**RE: Construction Storm Water Inspection at Delaware Place Senior Apartments
Delaware County. Permit Number: 4GCO00086*AG**

This letter is written regarding a storm water inspection conducted by Jerome Hoke and Elizabeth Pleta, of the Ohio EPA at the Delaware Place Senior Apartments located at 351 South Sandusky Street on September 12, 2013. The purpose of the inspection was to evaluate compliance with the General Storm Water Permit associated with Construction Activities. During the inspection, our staff noted the following issues associated with construction activities at this site:

Figure 1: Silt fence adjacent to the stream is overburdened and requires maintenance.

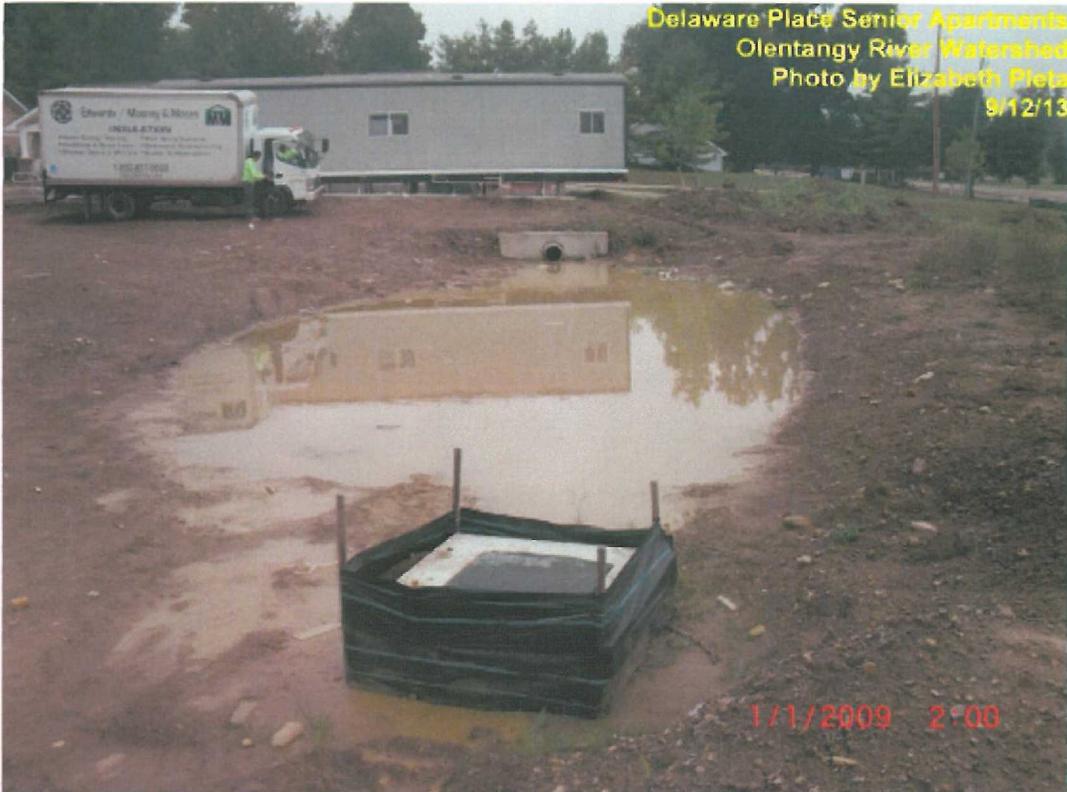
- Silt fencing on the southern portion of the site appeared to be overburdened (See Figure 1). The location of the silt fence, adjacent to a tributary stream in the Olentangy River Watershed, demands greater maintenance procedures than have been followed to date. Maintenance is required within three (3) days from receipt of this letter.
- A temporary riser or skimmer remained absent from the sediment basin on the east side of the site, as noted in a previous inspection (See Figure 2). Entrenching silt fence around the outlet structure, as noted, is **not an acceptable alternative**. If corrections are not made upon our next inspection, further compliance measures will be taken on behalf of the Ohio EPA.
